Access Compliance Report

Public Rights-of-Way

Intersection ID: 15889	Main Street: HERTFORD_RD	Cross Street: PEMBROKE_AV	Location: SE
ADA ID: A66DE2533142	Ramp Type: Directional1	Initial Pass/Fail: Fail	Overall Compliance: No
		Severity Score: 37.5

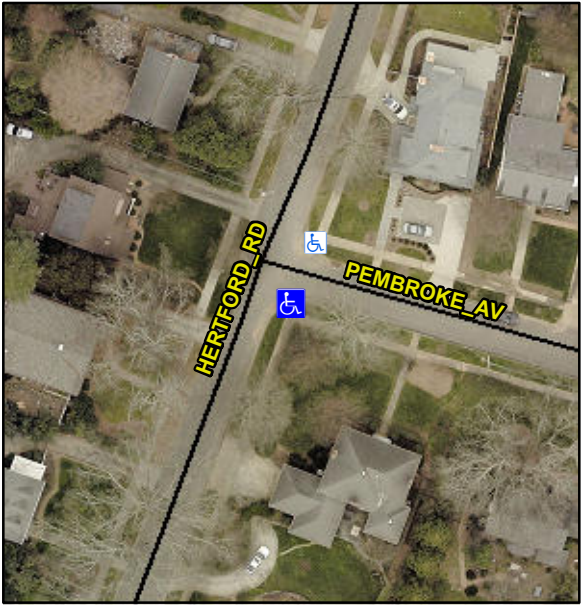
Codes/Mitigation Info/Possible Solution			Field Measurements/Component Compliance			
 <p>Street 1 Name PEMBROKE AV</p> <p>Stop Condition-Street 1 StopSign</p> <p>Street 2 Name N/A</p> <p>Stop Condition-Street 2 N/A</p>	Possible Solutions:		Compliance	Description	Data	
	Remove & Replace Entire Ramp.		N/A	Ramp Length (in)	51.0	
			Yes	Ramp Width (in)	48.0	
			No	Ramp Slope (%)	12.5	
			No	Ramp XSlope (%)	6.1	
			N/A	Flare Type LT	N/A	
			N/A	Flare Slope LT (%)	N/A	
			N/A	Flare Traversable LT?	N/A	
			N/A	Landing Length (in)	0.0	
			N/A	Landing Width (in)	0.0	
			N/A	Landing Slope (%)	0.0	
			N/A	Landing X Slope (%)	0.0	
			N/A	Landing Curb? (Y/N)	N/A	
			N/A	Shared Landing?	N/A	
			N/A	Gutter Ponding?	0.0	
			N/A	Gutter Lip Ht (in)	0.0	
			N/A	Painted X Walk1?	No	
				X Walk 1 Direction	To N	
				X Walk 1 Width (in)	N/A	
				X Walk 1 Slope (%)	8.1	
<p>Surveyor Notes:</p> <p>N/A</p> <p>PROW/ADA:</p> <p>R304.2.2, R304.5.3</p>
